Airport Business Park Station

Construction Traffic Management Plan

Document no. SMWSASSM-PLD-ABP-TF-PLN-000001

Date: 14/07/2023

FIGURE 6: ABP SITE ACCESS

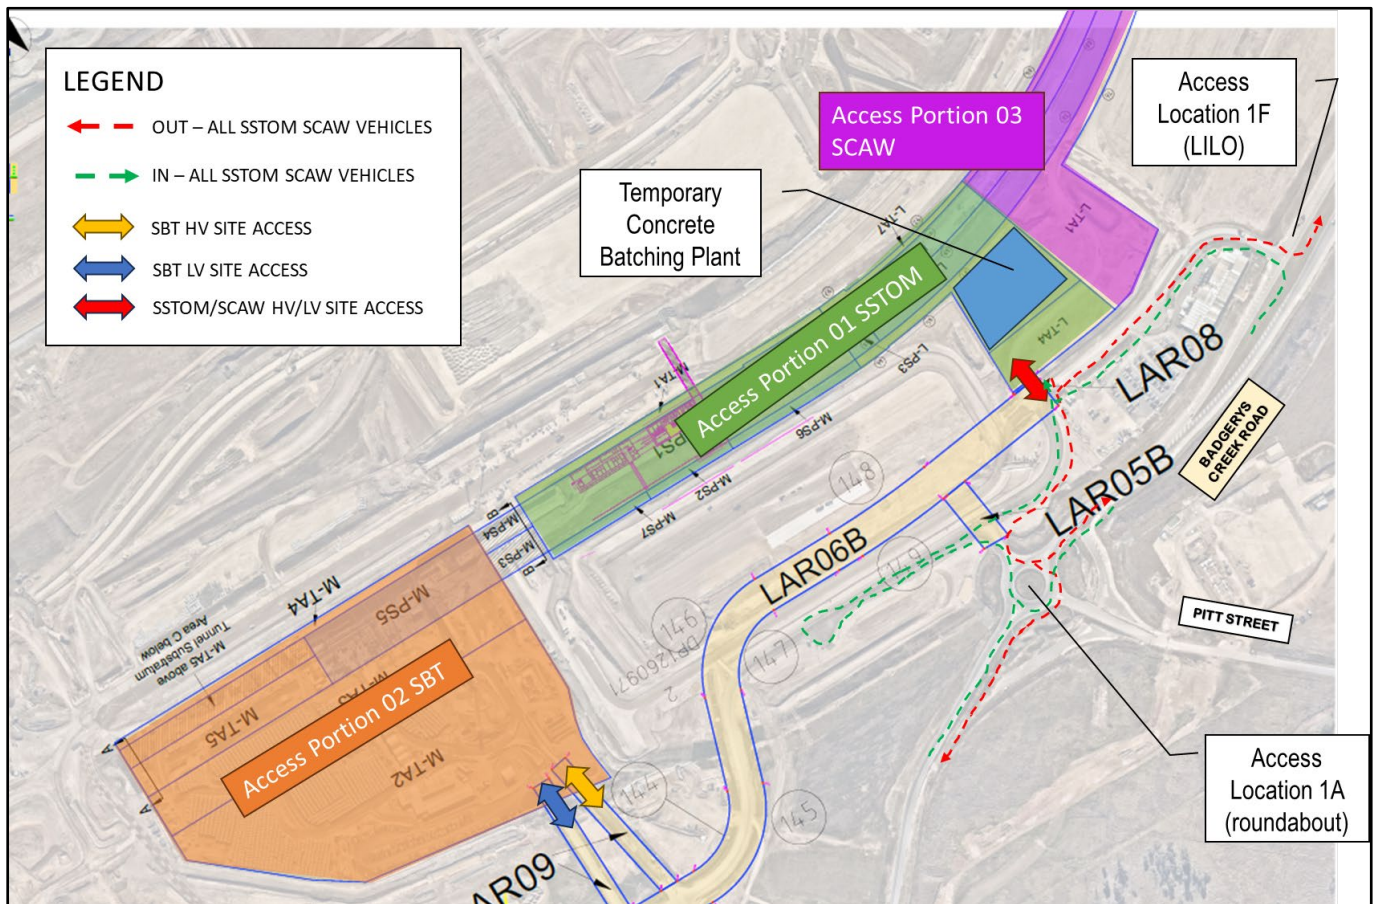
6/07/2023	PLD	WZHENG	SMWSASSM-PLD-ABP-TF-PLN-000001	Figure 10	NA	Figure 6 (was 10) has been updated to split the entering / exiting traffic	Observation		N
03	14/06/2023	TFN	LWILBY	SMWSASSM-PLD-ABP-TF-PLN-000001	Section 5.2 Pedestrian / Cyclist Impact Management	NA	Consider adding that there is also a wide sealed shoulder between Elizabeth Dr and Pitt St that provides greater space for cyclists and potential separation with heavy vehicles.	Observation		N
	6/07/2023	PLD	WZHENG	SMWSASSM-PLD-ABP-TF-PLN-000001	Section 5.2 Pedestrian / Cyclist Impact Management	NA	Updated in Section 5.2	Observation		N
04	14/06/2023	TFN	LWILBY	SMWSASSM-PLD-ABP-TF-PLN-000001	Appendix D Road safety audit	CTMF requirements	It appears that the road safety audit has been accidentally left off the document upload (finishes on page 31 of 39). Please upload additional pages with completed road safety audit as per the requirements in the CTMF.	Actual Non-Compliance		N

FIGURE 8: CONSTRUCTION VEHICLE ACCESS ROUTE

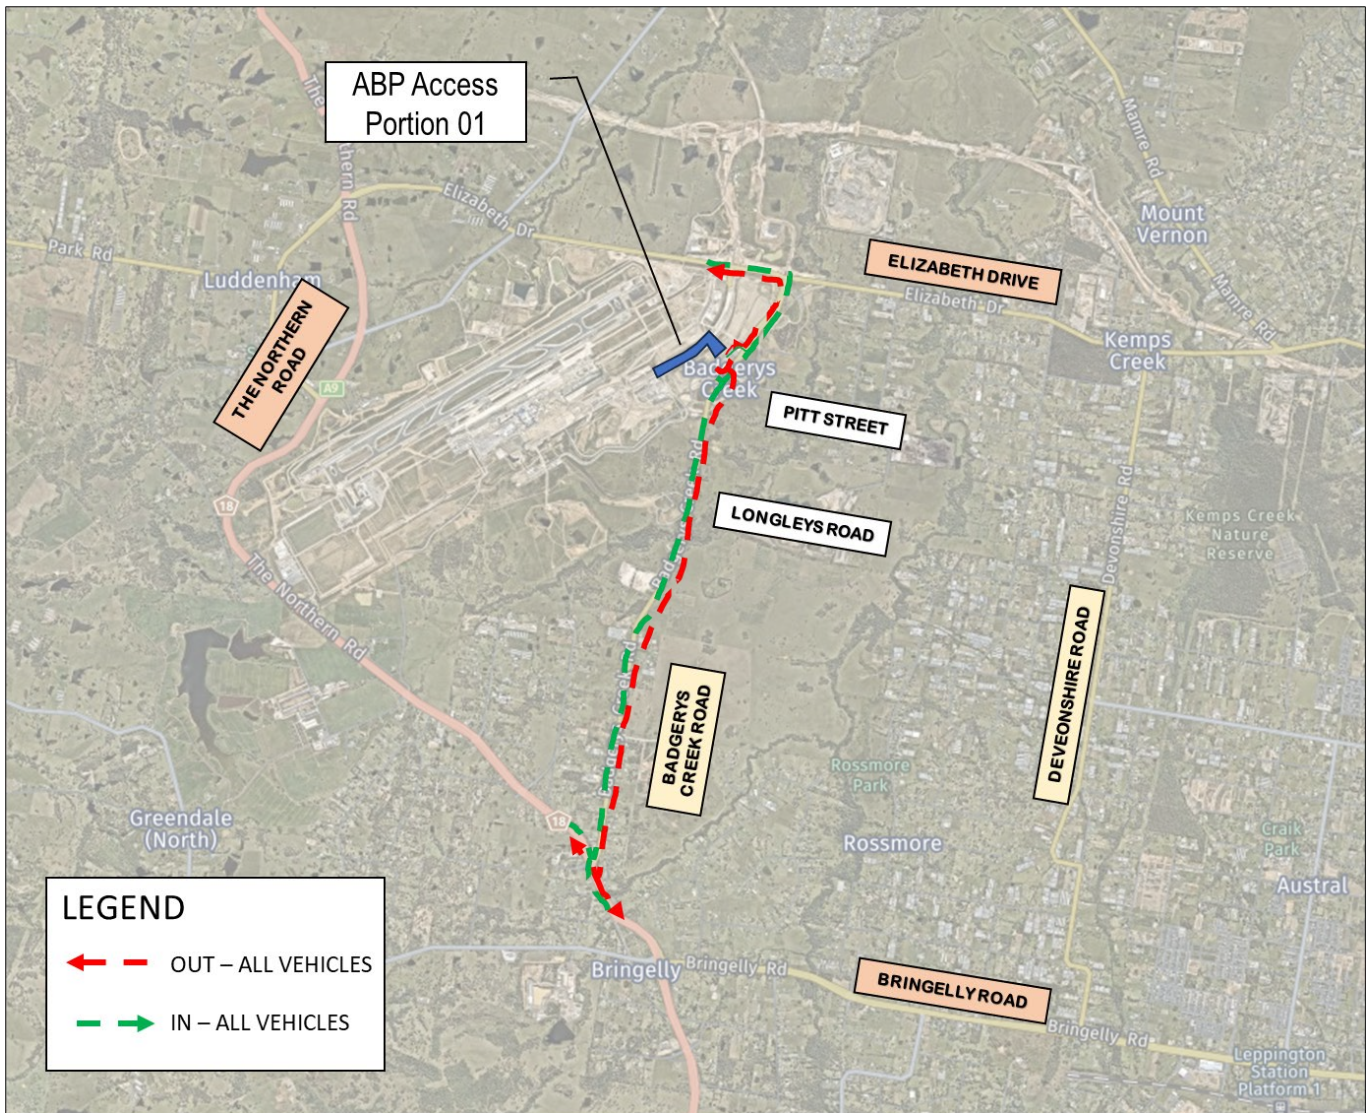
NO.	DATE	COMPANY	RAISED BY	REVIEW DOC. NO.*	DOCUMENT REF*	DEED REF*	COMMENTS / RESPONSE	COMMENT CATEGORY*	LINKED ITEM NO	CLOSED OUT
01	14/06/2023	TFN	LWILBY	SMWSASSM-PLD-ABP-TF-PLN-000001	4.6.2 Truck routes	NA	The paragraph on figure 7 correctly states that no bicycle paths available along either route, however cyclists may be legally riding along the road with general traffic. Consider updating wording, and site specific awareness for drivers to reflect this.	Observation		N
	6/07/2023	PLD	WZHENG	SMWSASSM-PLD-ABP-TF-PLN-000001	4.6.2 Truck routes	NA	Drivers to site will be all licenced and be made aware of cyclists on road through the following measures: - toolbox talks - inductions - Sydney Metro Safe Heavy Vehicle Driver Introduction Programme (Appendix E) - Drivers Code of Conduct (Appendix E) - NSW Road Rules Act 2014 Section 5.2 has been updated accordingly	Observation		N
02	14/06/2023	TFN	LWILBY	SMWSASSM-PLD-ABP-TF-PLN-000001	Figure 10	NA	Figure 10 appears to show an exiting vehicle short cutting in the wrong direction through the roundabout at Pitt Street. Please update to show correct route.	Observation		N

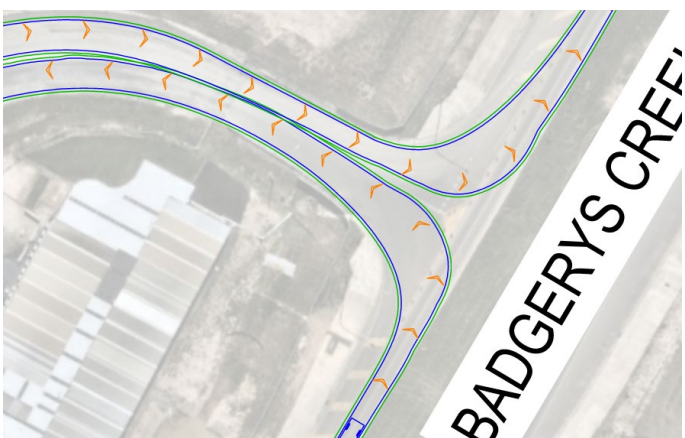
1.3. The swept path shows the 25 m articulated vehicle turning left in and out from the through lane at access 1F.

The snake channelisers have been installed between the turn lane and the through lane.

This restricts movements and may cause confusion for motorists, resulting in a minor crash.

Likelihood: Possible
 Severity: Insignificant
 Risk rating: **LOW**

Swept path assessment revised with 19m AV on newer aerial image base. No additional traffic management devices are required.

Recommendation has been given to TfNSW to provide additional warning signs on approach to the left turn lane.

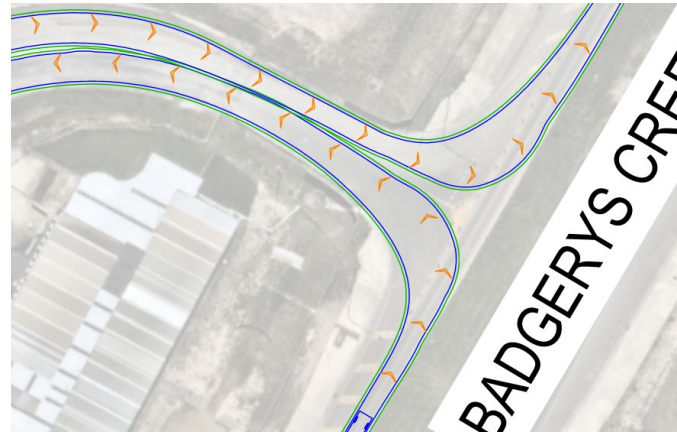
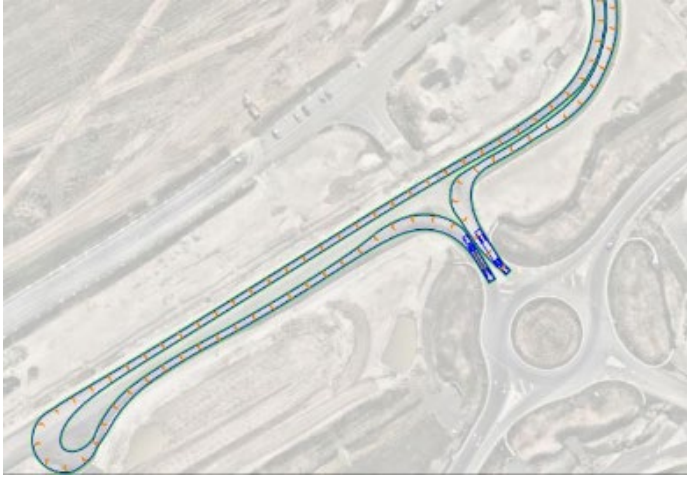
1.4. The swept paths indicate that heavy vehicles must turn left in from the through lane at access 1F.

Light vehicles may attempt to enter the left turn lane whilst a heavy vehicle is turning left in from the adjacent through traffic lane.

This may result in a side swipe crash.

Likelihood:
Rare

Risk rating:
MEDIUM

Revised swept path with 19m AV show HV can turn left from left lane at access 1F. LVs will queue behind HVs and vice versa.
